IMAX Darling Harbour

*State Significant
Development
Modification Assessment
(SSD 7388 MOD 7)*

July 2019

Figure 4 | Roof plan showing proposed open roof area above level 22 pool area (Base source: Applicant's Architectural drawings).

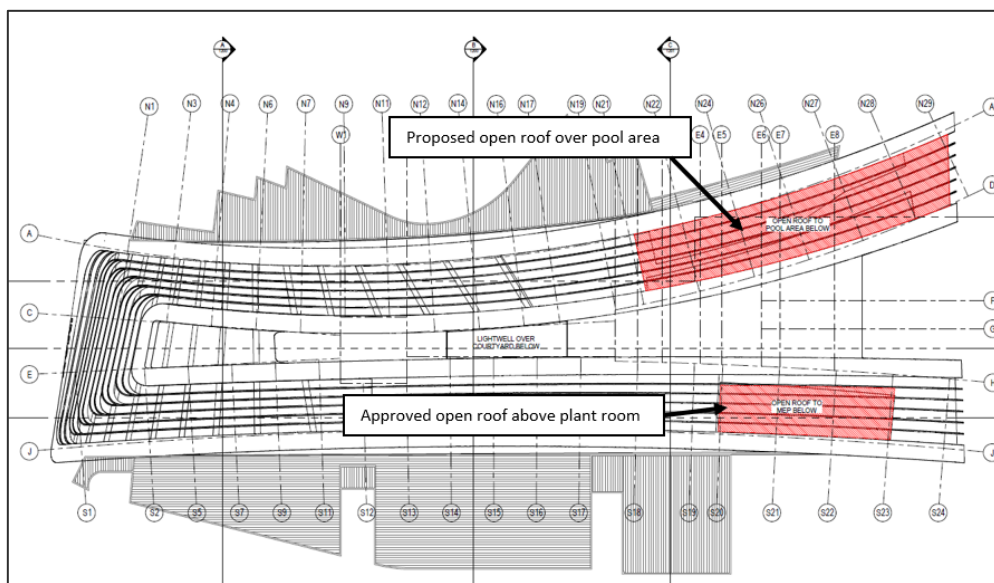
- create an open roof over the level 22 and 23 pool and bar area (**Figures 4 and 7**) including installation of internal Nitrogen Dioxide (NO₂) monitoring equipment and alarm system (**Figures 5 and 6**).
- allow the use of balconies, terraces and operable windows above a height of 60m above ground level (Condition B30)
- allow operable roof louvres to be opened outside of scheduled maintenance and repairs (Condition F2).

Figure 5 | Section showing proposed open roof area above the level 22 and 23 pool and bar area and location of NO₂ monitors and alarm (Source: Applicant's Architectural drawings).

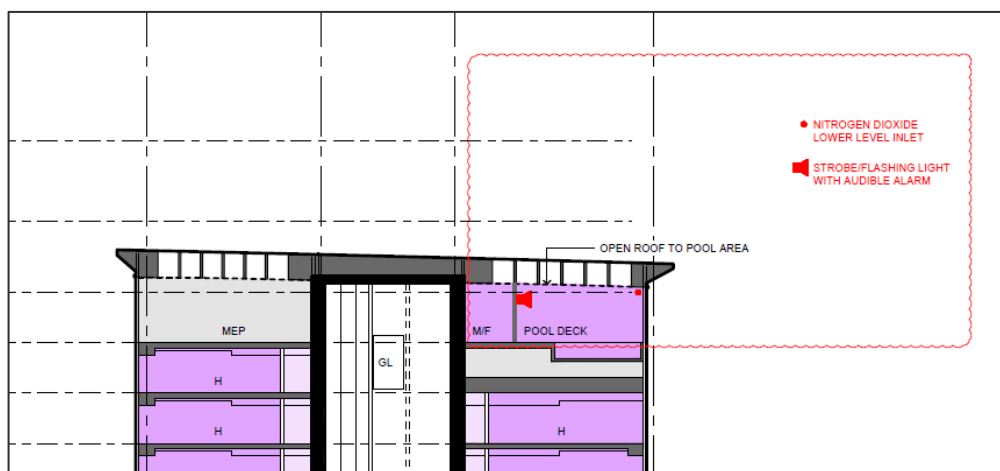
To ensure the safe operation of the pool area during both normal circumstances and in the event of an incident within the CCT, the Applicant proposes to install NO₂ monitoring equipment within the level 22 and 23 pool area which will inform the monitoring/alarm protocol proposed in the AQA (**Table 5**).
